Access Compliance Report

Public Rights-of-Way

(Curb Ramps)

Intersection ID: 31442	Main Street: LORDEN_AV	Cross Street: RIDING_HILL_AV	Location: NW
ADA ID: 38FE512D0A55	Ramp Type: BlendTrans1	Initial Pass/Fail: Fail	Overall Compliance: No
			Severity Score: 33.75

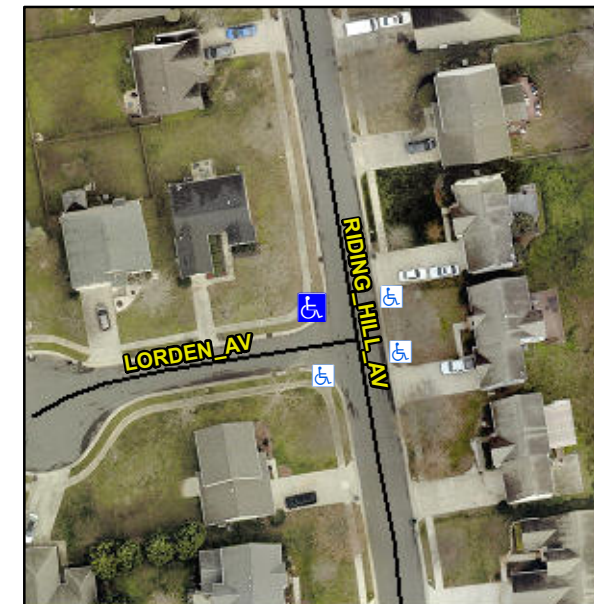
Not Found, R304.5.1, R304.5.3

Compliance	Description	Data	Compliance	Description	Data
N/A	Ramp Length (in)	54.0	Yes	BlendTrans Slope (%)	3.3
No	Ramp Width (in)	40.5	No	BlendTrans XSlope (%)	7.6
N/A	Flare Type LT	N/A	N/A	Flare Type RT	N/A
N/A	Flare Slope LT (%)	N/A	N/A	Flare Slope RT (%)	N/A
N/A	Flare Traversable LT?	N/A	N/A	Flare Traversable RT?	N/A
N/A	Landing Length (in)	N/A	N/A	DWS Provided?	N/A
N/A	Landing Width (in)	N/A	N/A	DWS Contrast?	N/A
N/A	Landing Slope (%)	N/A	N/A	DWS Length (in)	N/A
N/A	Landing X Slope (%)	N/A	N/A	DWS Full Width?	N/A
N/A	Landing Curb? (Y/N)	N/A	N/A	DWS Offset (in)	N/A
N/A	Shared Landing?	N/A			
N/A	Gutter Ponding?	N/A	N/A	Gutter Slope (%)	N/A
N/A	Gutter Lip Ht (in)	N/A	N/A	Gutter X Slope (%)	N/A
N/A	Painted X Walk1?	No	N/A	Painted X Walk2?	No
	X Walk 1 Direction	To S		X Walk 2 Direction	To E
	X Walk 1 Width (in)	N/A		X Walk 2 Width (in)	N/A
	X Walk 1 Slope (%)	6.8		X Walk 2 Slope (%)	3.6
	X Walk 1 X Slope (%)	3.0		X Walk 2 X Slope (%)	7.5

N/A	Ramp inside XWalk1?	N/A	N/A	Ramp inside XWalk2?	N/A
	Road Slope (%)	3.6		Clear Space?	N/A
	Road X Slope (%)	1.6	N/A	Clear Space to XWalk (in)	N/A
N/A	Any Obstructions?	N/A	N/A	Storm Grate/Utility Hazard?	N/A
	Obstruction Type			Storm Grate/Utility Type	
		N/A			N/A
			Yes	Surface Condition? (G/P)	Good
			No	Curb Slope (%)	9.0

Remove & Replace Curb Ramp With Two New Directional Ramps or Equivalent.
